NOTICE OF A PUBLIC MEETING OF THE
CITY COMMISSION OF THE CITY OF BROWNSVILLE

1. Sheet M3.4:
    a) Revised Building Chilled Water Schematic Diagram. See attached sheet.
    c) Clarification: Under the Base Bid, provide the differential pressure (DP) sensor, motorized bypass valve, and all associated materials, controls, and sequence of operation at DOAS-4. In the event Alternate #1 is accepted, this scope shall instead be provided for DOAS-5 and not DOAS-4. Provide pipes and valves sizes accordingly. Coordinate with Prime, Mechanical and Controls Contractor.

01 ELECTRICAL RENOVATION FLOOR PLAN
SCALE : 1/8" = 1'-0"

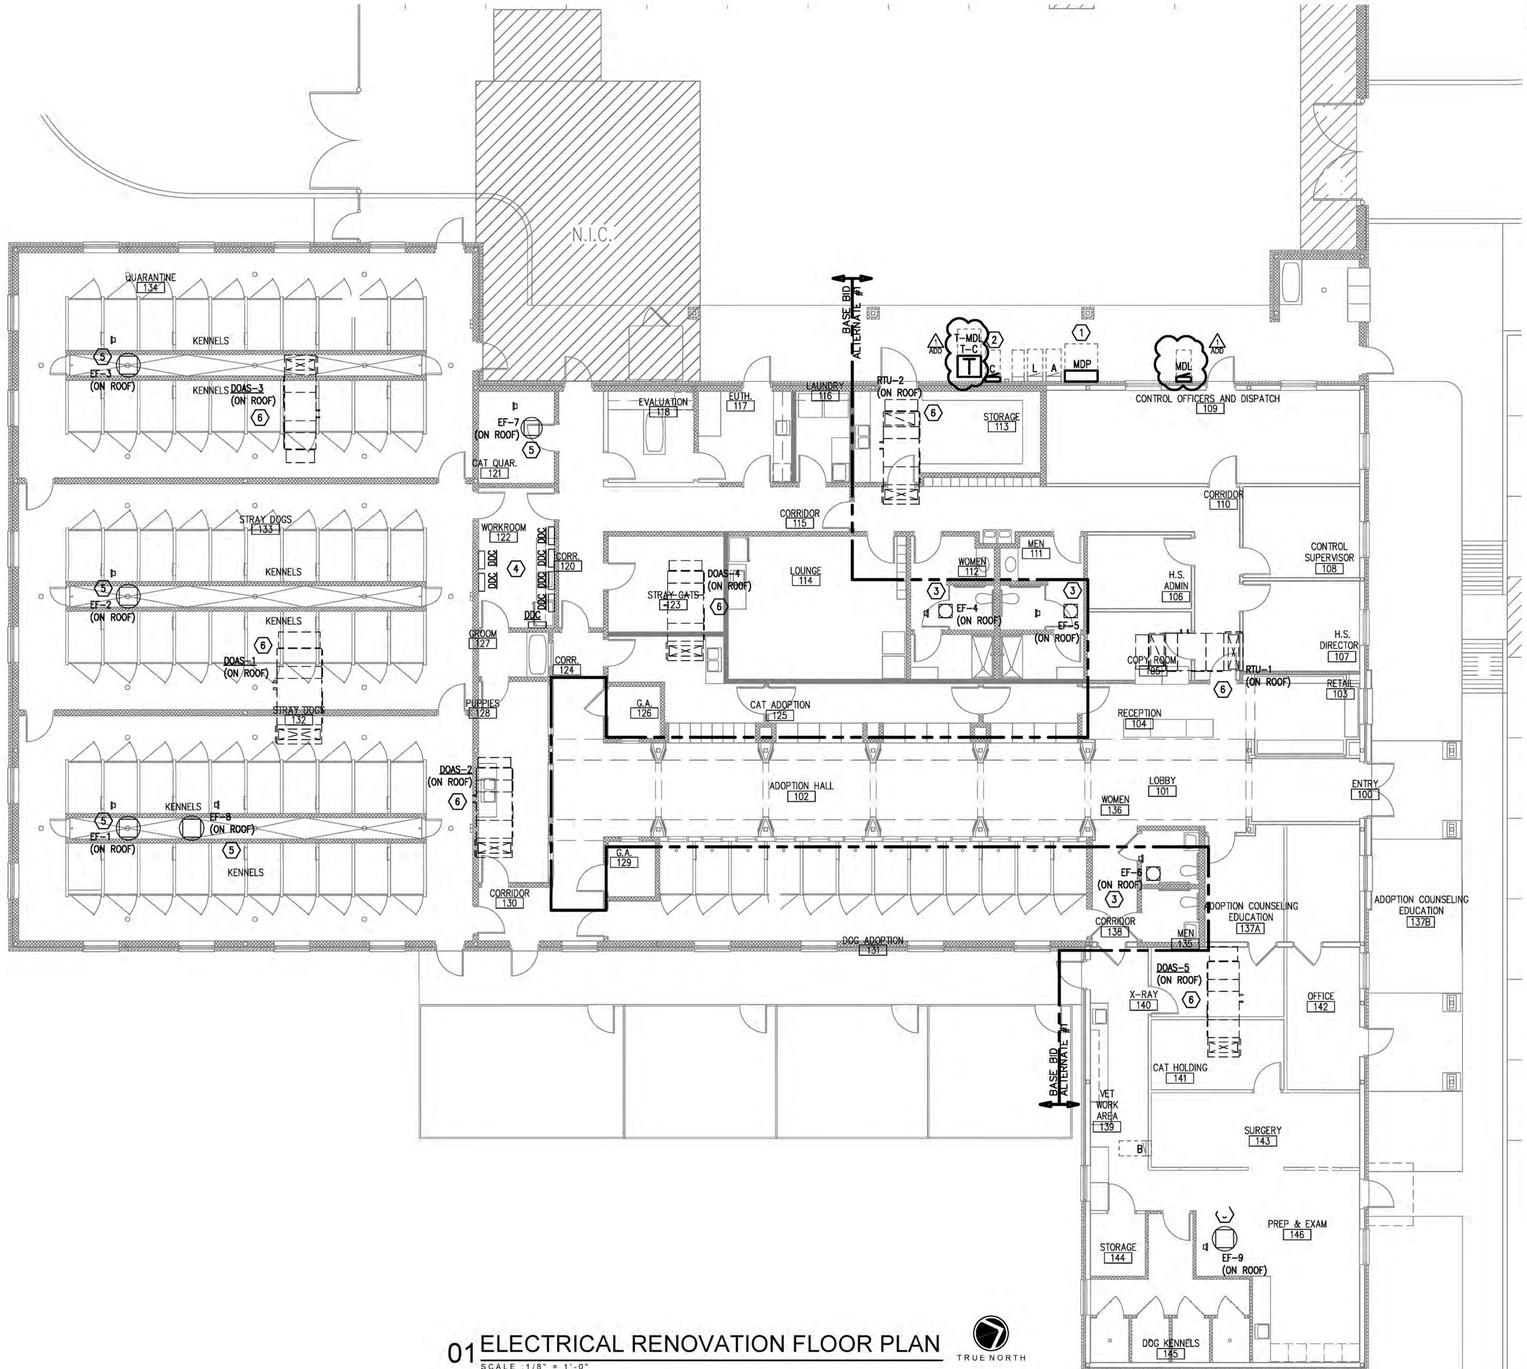
4. Sheet E3.1:
    a) Revised Electrical Renovation Floor Plan. See attached sheet.

02 UPGRADES ELECTRICAL RISER DIAGRAM

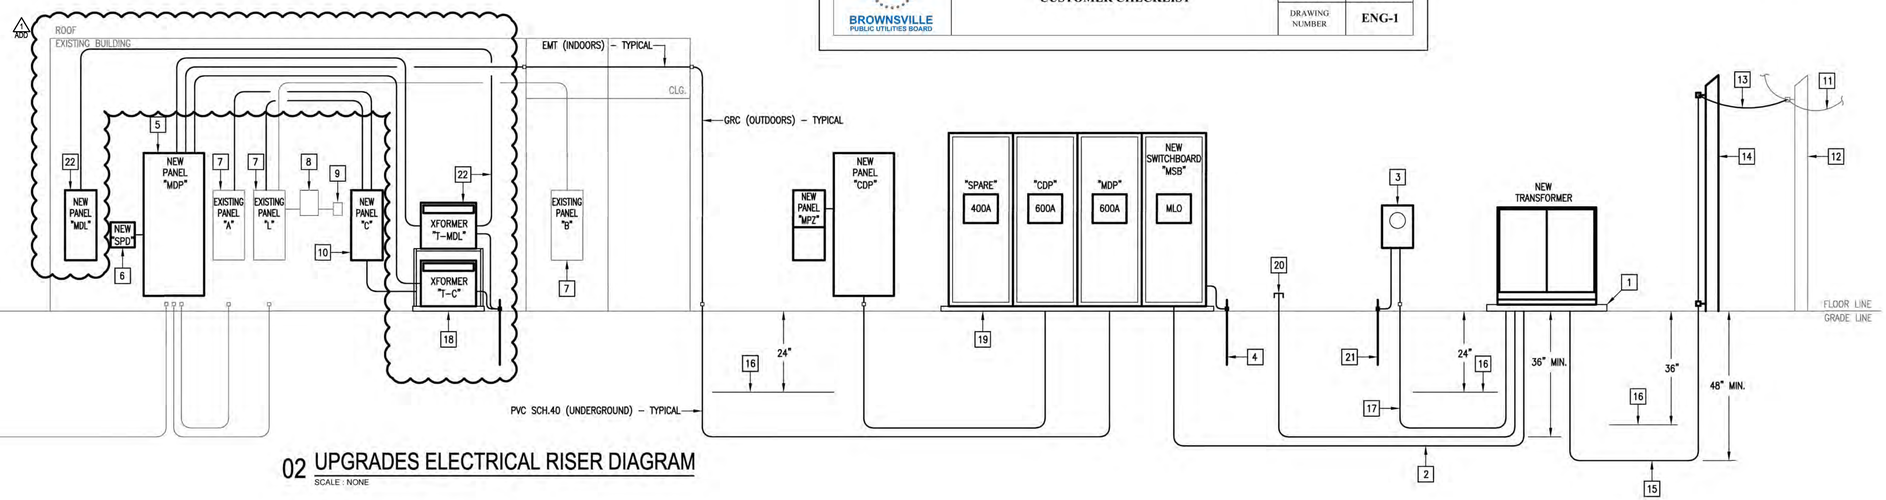
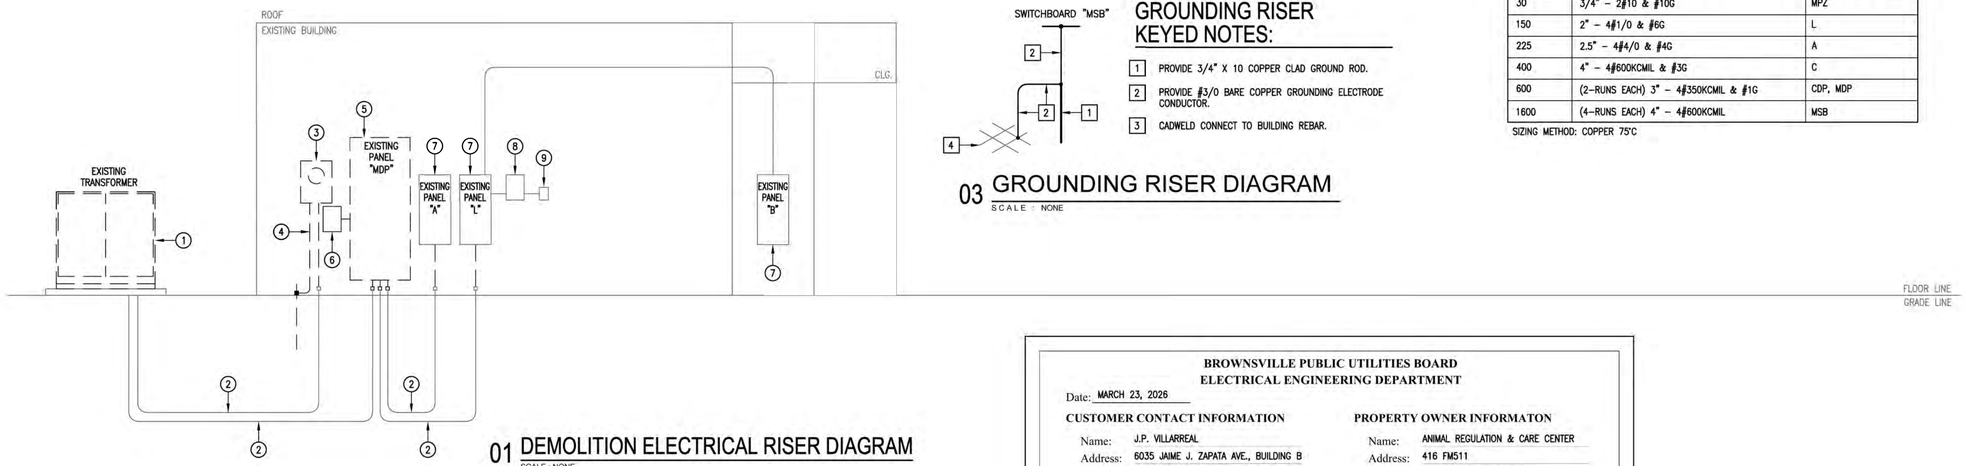
5. Sheet E4.1:
    a) Revised Upgrades Electrical Riser Diagram. See attached sheet.

1 STRUCTURAL DEMOLITION/ROOF DECK INFILL FRAMING PLAN

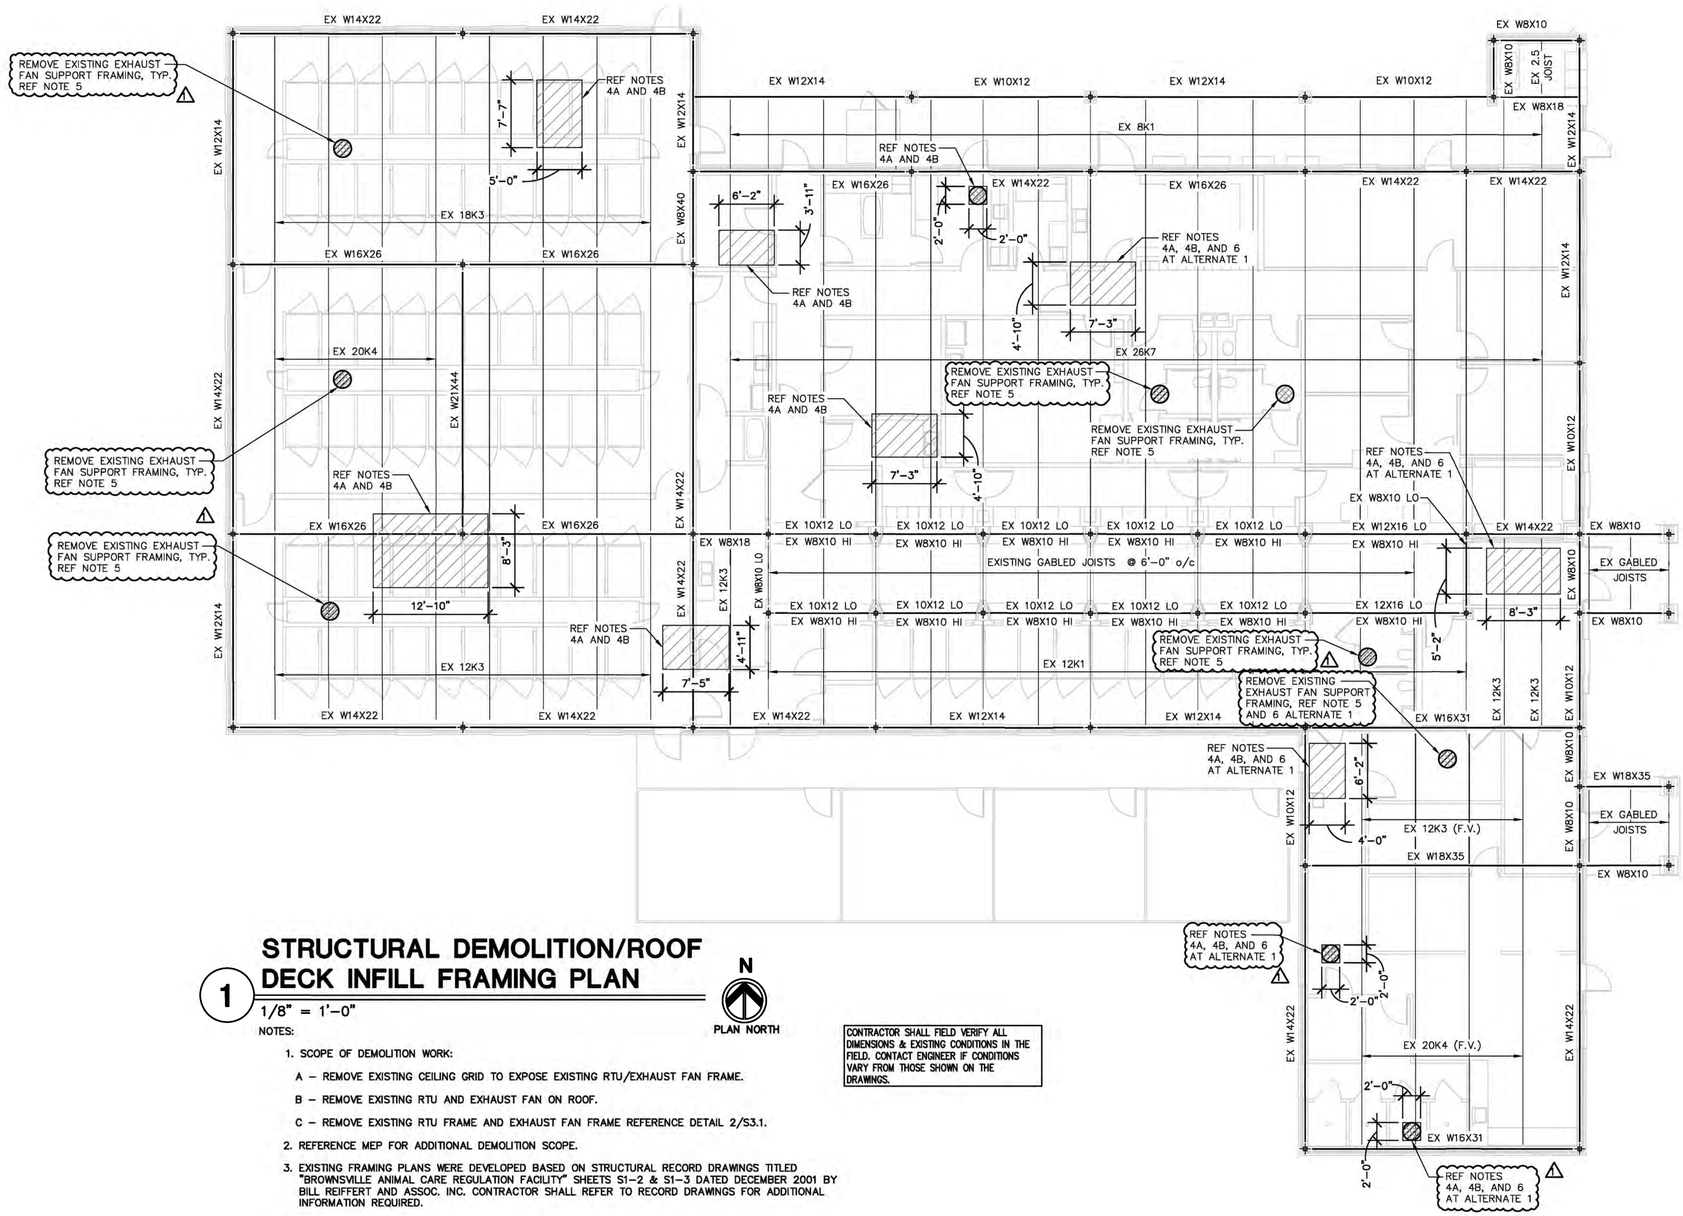
8. Structural Engineering Sheets have been revised. See revisions on attached sheets:
    a) S2.1
    b) S3.1
    c) S3.2

01 MECHANICAL DEMOLITION FLOOR PLAN

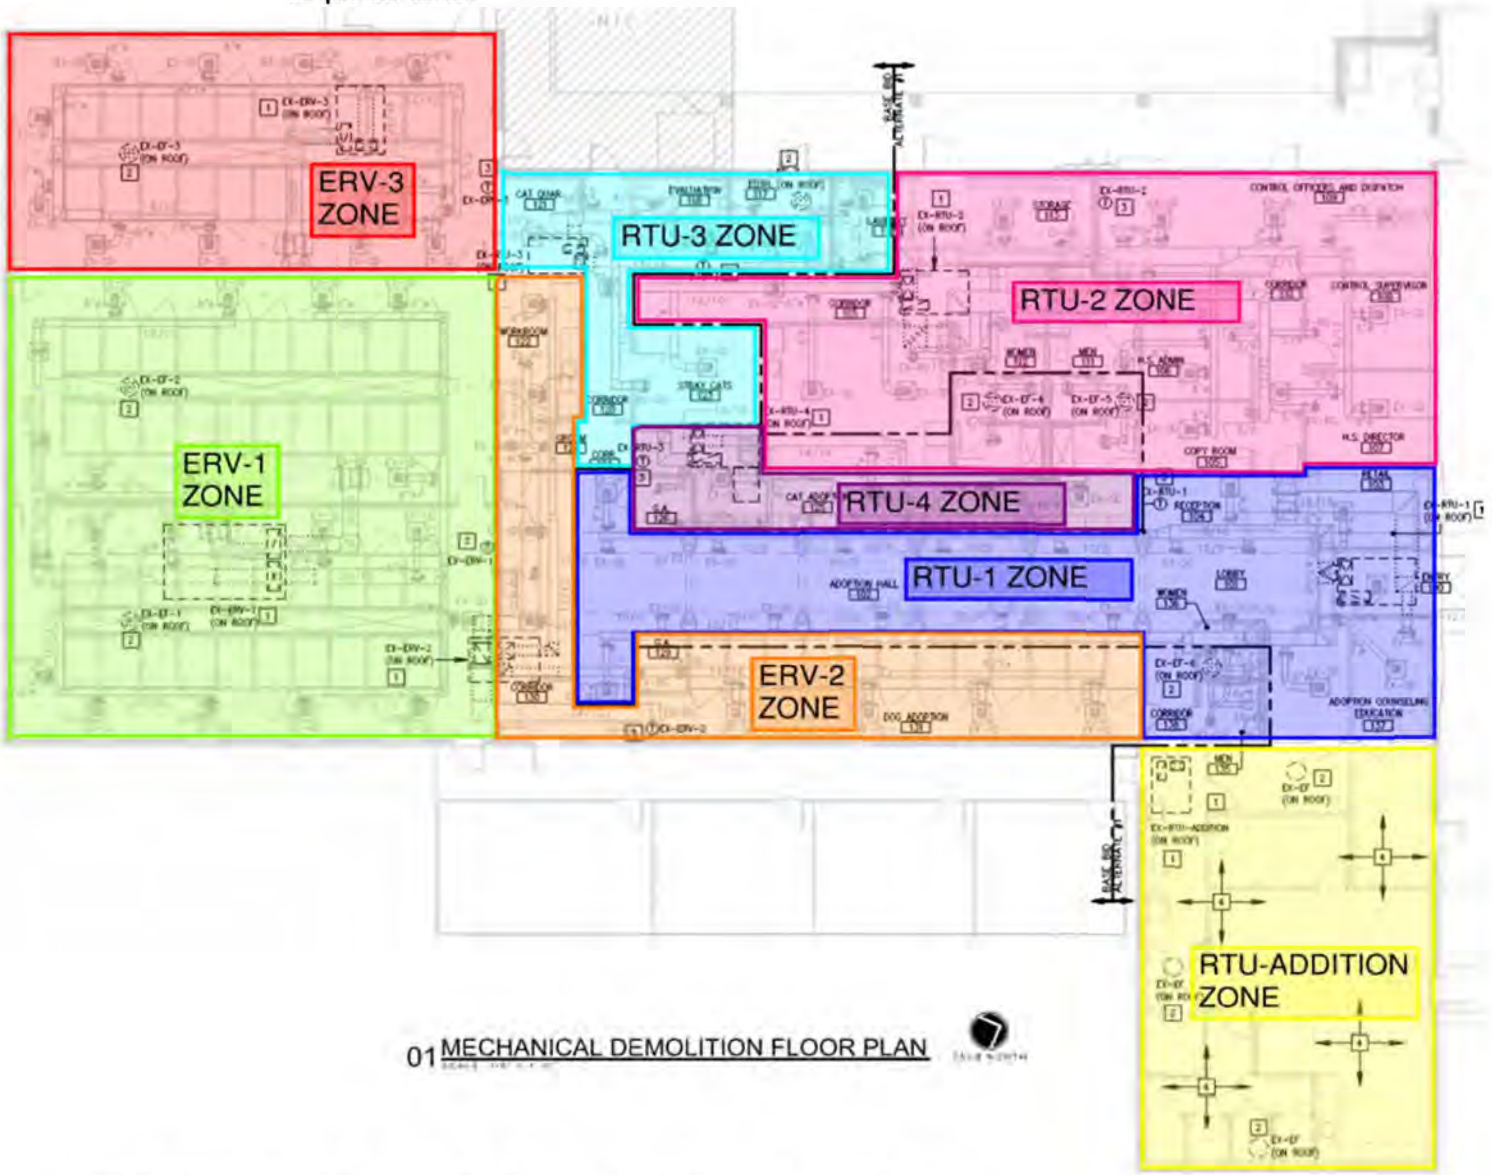
2. Sheet M1.0:
    a) See attached revised sheet. Added Sequences of Construction.

01 ELECTRICAL RENOVATION FLOOR PLAN
SCALE : 1/8" = 1'-0"

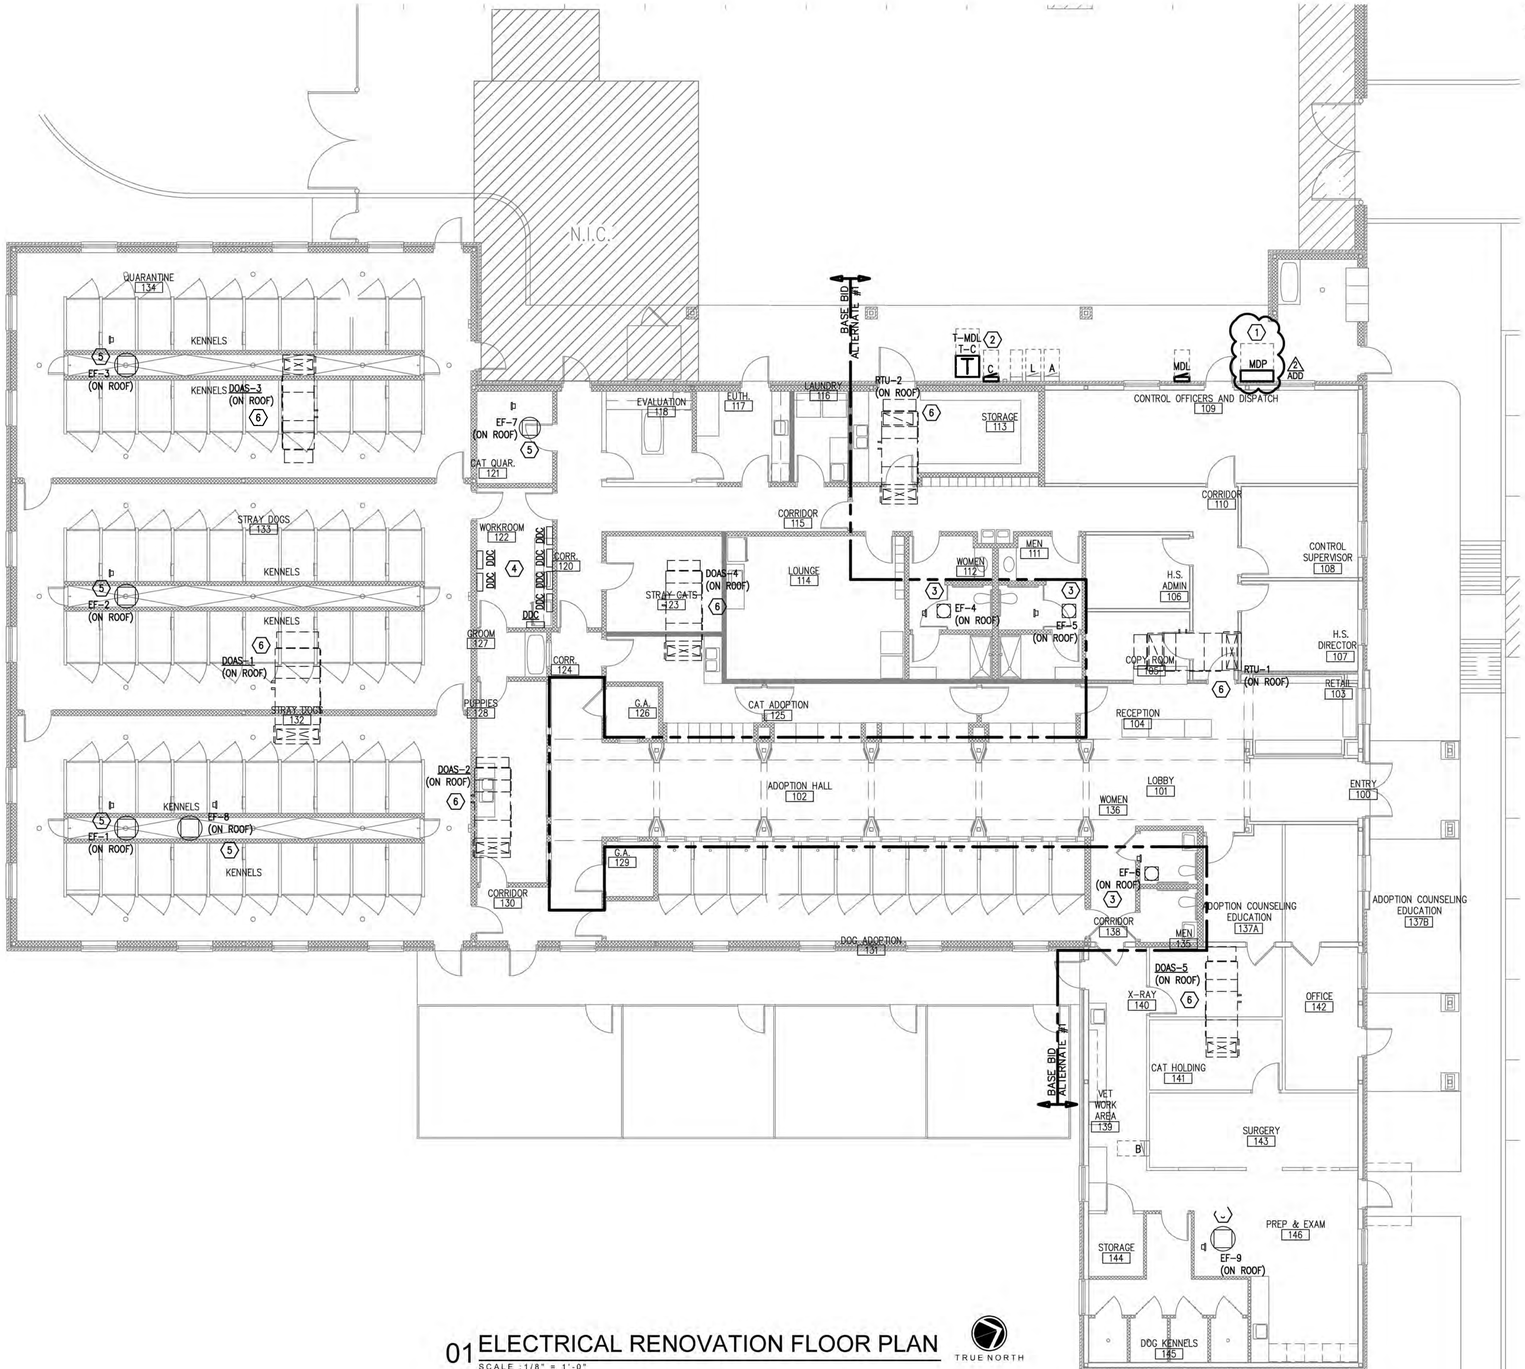
4. Sheet E3.1:
    a) See attached revised Electrical Renovation Floor Plan illustrating the relocation of Panelboard "MDP".
